Product Bulletin 270

NOTIFICATION Product Release

Product Schüco ASE 39.PD.NI.HD Panel Centering Bracket

Schüco ASE 39.PD.NI.HD Panel Centering Bracket (x10)

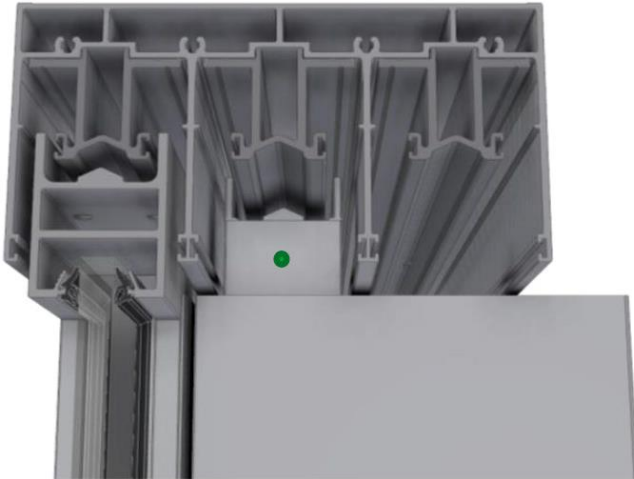
As Schuco continues to grow in Australia Capral has added the following component to the ASE 39.PD.NI.HD Panoramic Sliding Door.

The door will now have a panel centering bracket that is an alternative to the existing adhesive Centering Strips “284878”. This bracket fitted onto the panel in the head is integral to the high performance the door offers

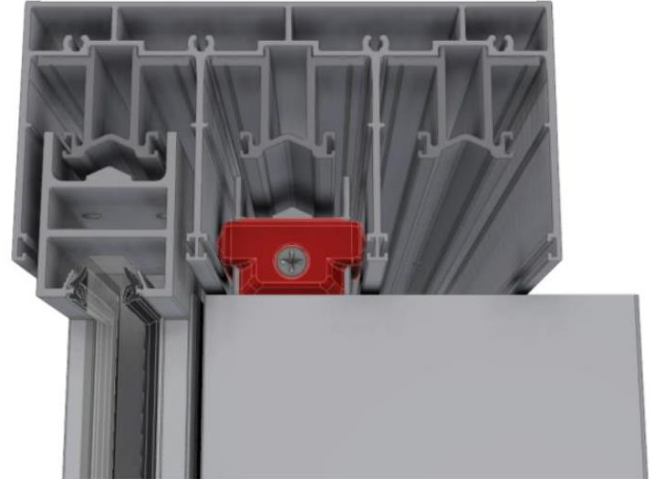
The part is fitted to both ends at the top of the sliding door panel, with a single countersunk screw, after the panel is installed into the sliding track of the outer frame. Pre-drilling a pilot hole using the part as a template is suggested for easier assembly

Panel installed in head track. Drill pilot hole prior.

Fit component (shown RED) onto panel, snugly between head track walls.
